SITE: Penns Field

# **Design Review Panel Meeting Notes**

DATE: 18th July, 2016. TIME:11:00 – 12:00 VENUE: Chanctonbury

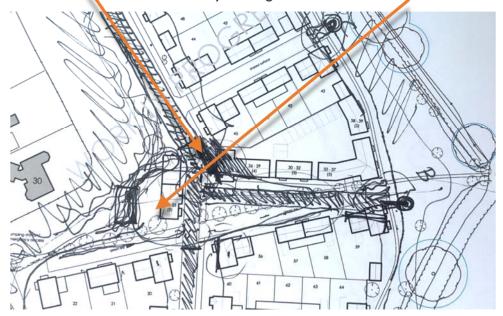
- It was suggested that moving the northern part of the spine road to the west by 5degrees/5m would allow the block to be more developable and create better orientation of the plots within the block. It would also better align the view from the central focal point to the north.
- The intersection of spine road and lane at the central focal point of the scheme would be more comfortable if it has the character of a lane and not a vehicular 'cross-roads'. This area should be further developed to create a central 'place', and not be dominated by the road.
